ABP Ref: ABP-310466-21

Further Development of a Quarry**Application under Section 37L of the Planning and Development Act 2000, as amended.****Laurence Behan, Windmill Hill, Rathcoole, Co. Dublin**

I refer to the above and to your letter of 24th February 2023 requesting a response, where the applicant is so minded, under Section 131 of the Planning and Development Act 2000, as amended, to a number of observations received from third parties.

Figure 1: Location and distance between the nearest part of the subject quarry and the end of the nearest runway at Casement Aerodrome

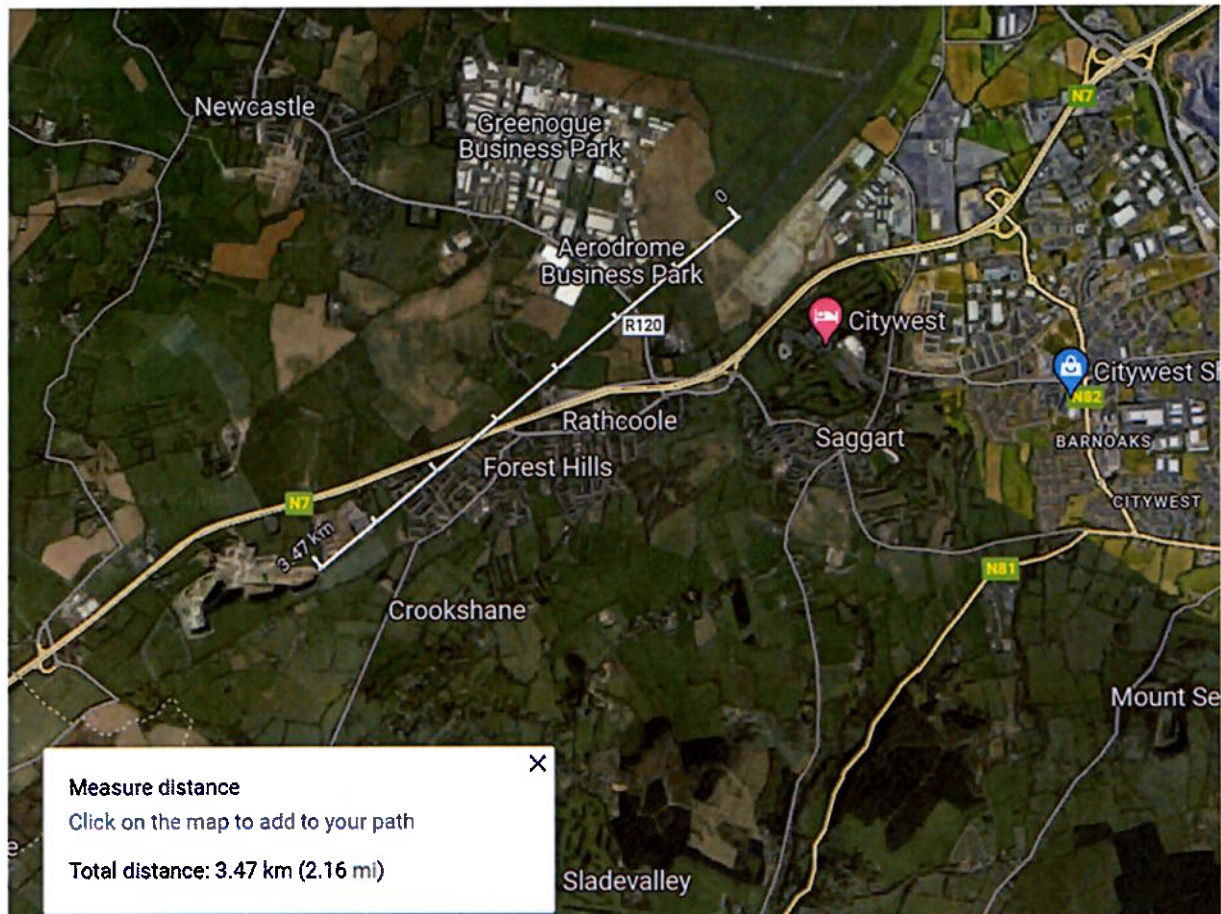
'Due to the proximity to Casement Aerodrome and to low level routes, Military Air Traffic Services requests an Aviation Impact Assessment on all potential effects on Irish Air Corps flight operations.'

The aerodrome in question is located some 3.47km from the end of the runway nearest the quarry in question to the nearest point of the quarry. This is considered a relatively substantial distance away. Figure 1 below shows the respective locations and the measures distance as the crow or plane flies from one to the other.

It should also be clear from Figure 1 above that the quarry the subject of this S37L application is not located on the direct flight path of either of the only 2 no. runways at the aerodrome. We would therefore contest the expressed view of the Department that the subject quarry is in any way proximate to the aerodrome or either of its runways, even the nearest one to the quarry the subject of our client's application to the Board.

As can be seen from Figure 1 above, more directly aligned with the direction of the run way is the village of Rathcoole and the intervening housing estate at Forest Hills.

View 1 - Opposite the existing quarry entrance.

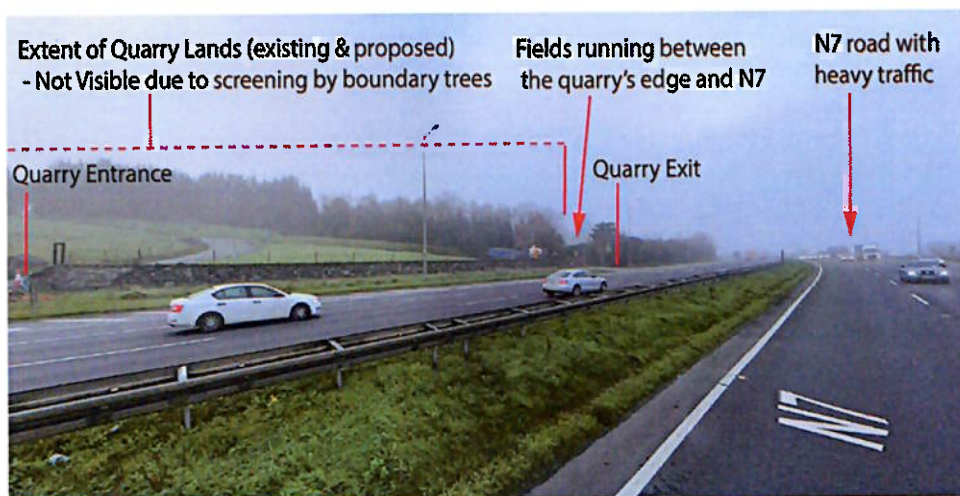
Due to road safety, it is not possible to undertake a photomontage from the N7, as requested, which is a busy national route. This is evident in the photographs below. However, as a reasonable alternative the following images have been annotated.

The existing trees and hedgerows screen views of the quarry and the proposed extension lands, with only the traffic on/off the quarry's entrance and exit visible. The image also shows how busy the road is with traffic.

Cross Section S37L RFI - A_A'

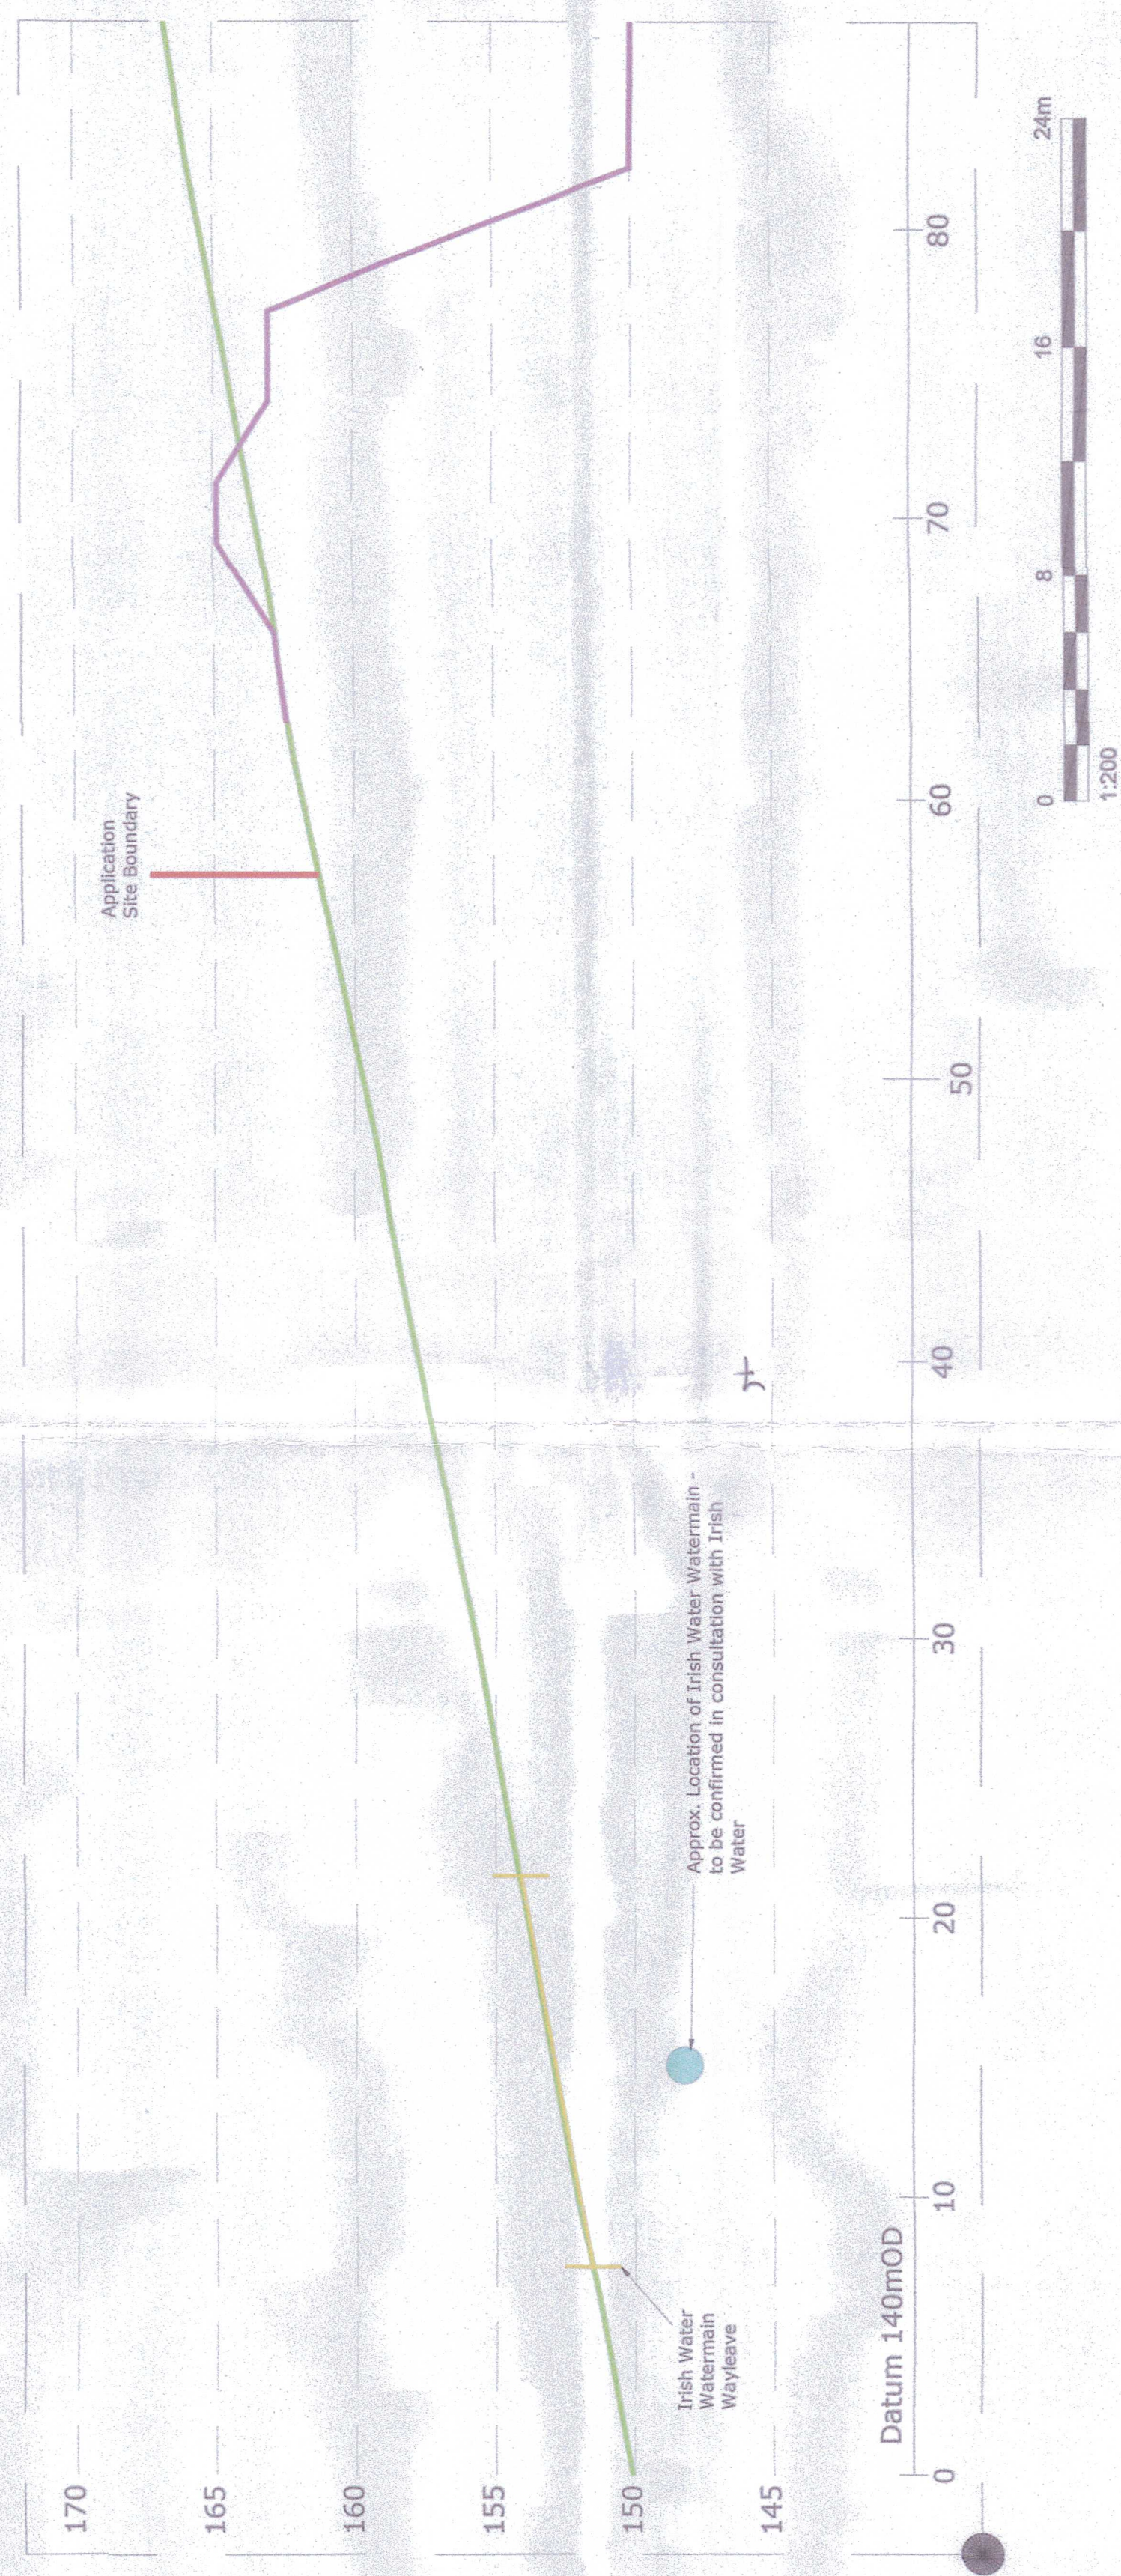
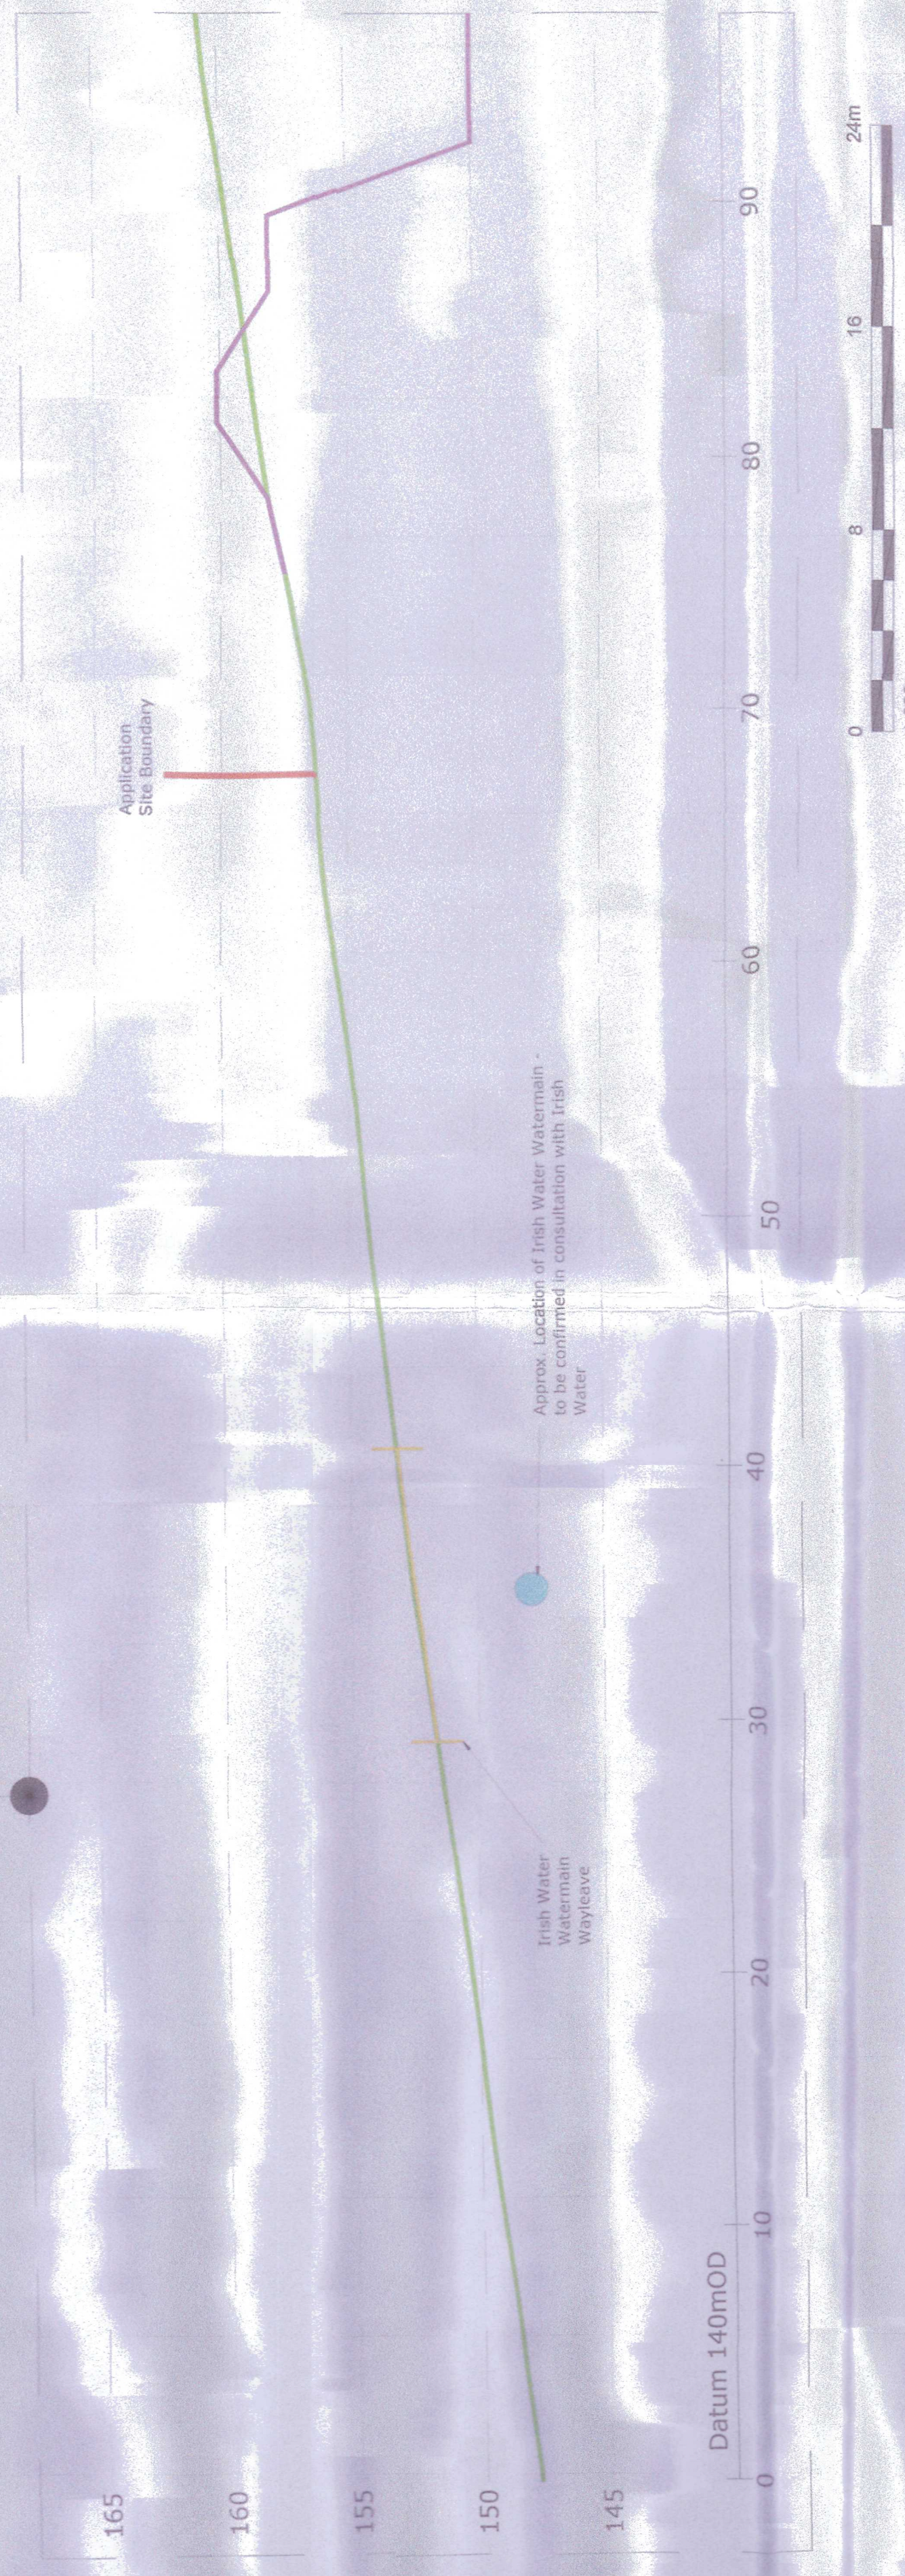
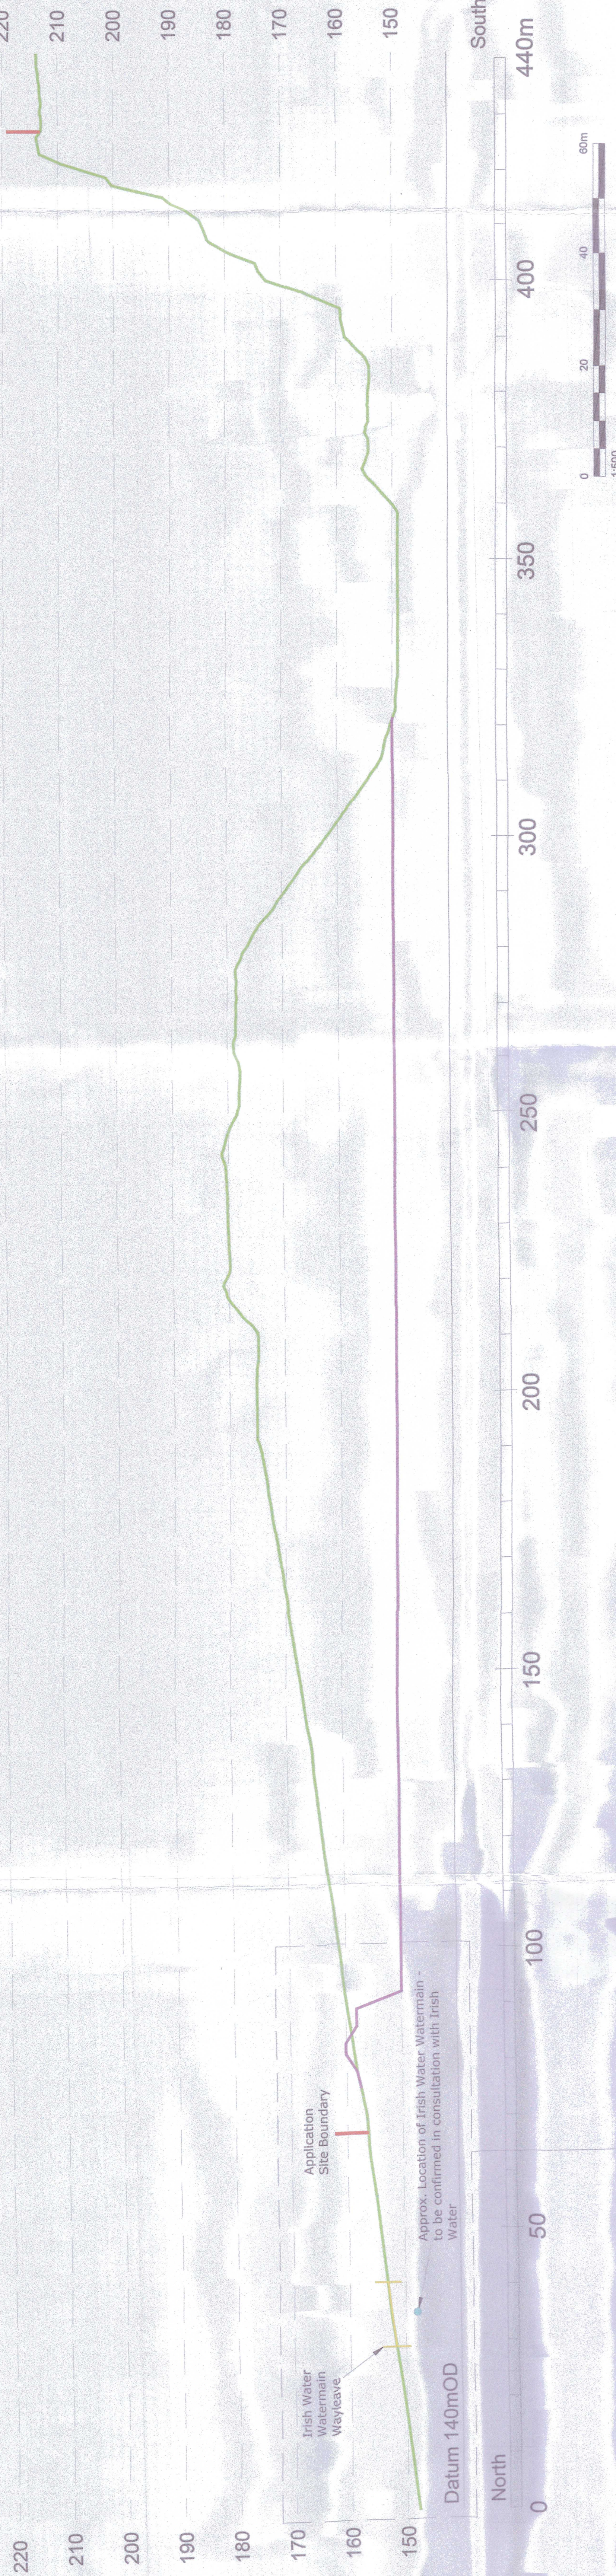
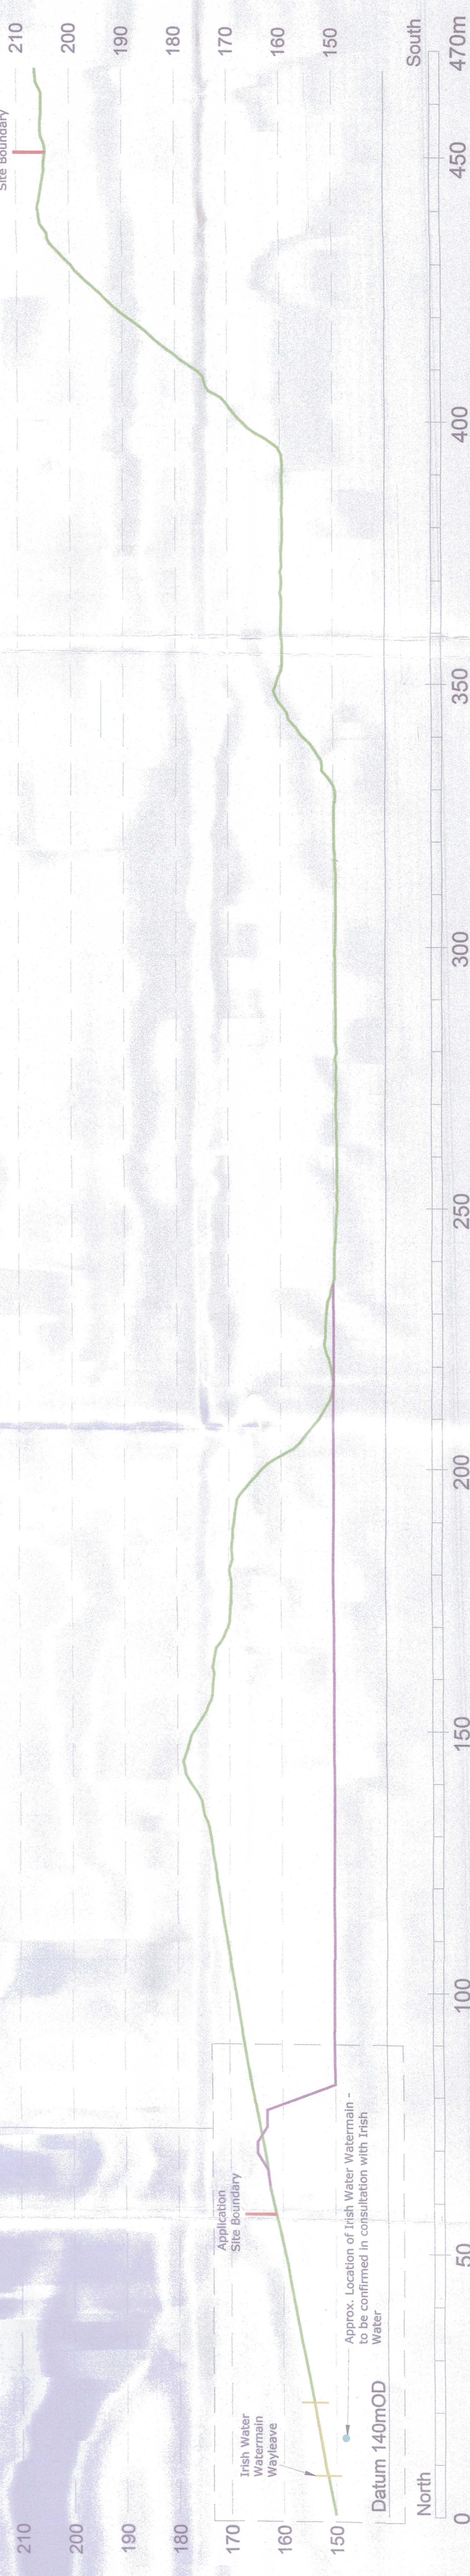
Item 5.3.7: Irish Water's Report requests additional information. The applicant is requested to submit a drawing in plan outlining the existing and proposed water supply layout for the development. Furthermore, Irish Water raises concerns regarding the proximity of the works to a 1270mm concrete public watermain that traverses the site from west to east. ADDITIONAL INFORMATION required to assess the impact of the development on this major infrastructural piece. Information pertaining to foul drainage is also requested by Irish Water.

Approximate locations of the watermain have been indicated on the cross section supplied with this response, Appendix A). Precise locations and other information requests with Irish Water will be identified through engagement with the applicant.
